WHATCOM COUNTY
Planning & Development Services
5280 Northwest Drive
Bellingham, WA 98226-9097
360-778-5900, TTY 800-833-6384
360-778-5901 Fax

RE: Notice of Additional Requirements (NOAR)
Conditional Use Permit – CUP2023-00001 & SEP2023-0005

Third Party Wetland Delineation and Verification Review Checklist

Figure 1: Wetland Map, Figure 3 from Critical Areas Report (December 2022), with 3rd party review comments.

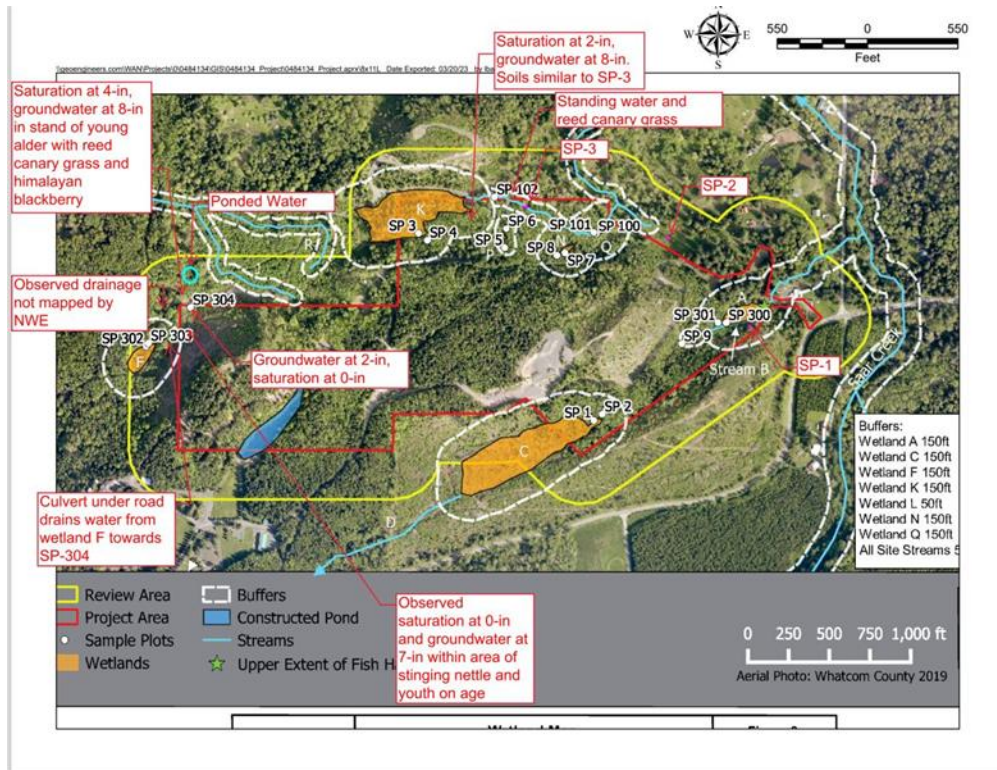
1. *Critical Areas Report (Wetland Delineation and HCA Assessment):*
 - a. The Natural Resource Consultant shall re-evaluate the wetland delineation boundaries, specifically the Data Plots evaluated in 3rd party documentation in red on the map in Figure 1 (See Figure 1 above and attached document).

- Observed areas with wetland hydrology and hydric soils
 - See attached marked up map
 - SP-1
 - Observed wetland hydrology, hydrophytic vegetation and hydric soils on right bank of seasonal stream across from Wetland A in area not delineated as wetland by NWE
 - SP-2
 - Observed ponding, hydrophytic vegetation, and hydric soils in area not delineated as wetland by NWE
 - SP-3
 - Observed wetland hydrology, hydrophytic vegetation and hydric soils in area shown as a stream, not wetland by NEW
 - Broad bottomed drainage dominated by FAC vegetation with silty soils

- Observed saturation at 2-in, groundwater at 8-in and soils similar to SP-3 in low lying area southeast of Wetland K
- Observed body of ponded water north of gravel road and west of Stream J

- Observed saturation at 0-in and groundwater at 7-in where NWE had SP-304
 - Area vegetated with willow, dense reed canary grass and Himalayan blackberry

- Observed saturation at 4-in and groundwater at 8-in within a stand of young alder with understory of reed canary grass and Himalayan blackberry north of and across the road from SP304

- Observed saturation at 0-in and groundwater at 7-in within an area vegetated with stinging nettle and youth on age southwest of SP-304
- Observed a culvert that drains Wetland F under a gravel road towards the area around SP-304

- Observed drainage not mapped by NWE north of Wetland F
- Rating form comments
 - Wetland A- incorrect HGM class rating form was used and multiple discrepancies identified that will be impactful regardless of HGM classification
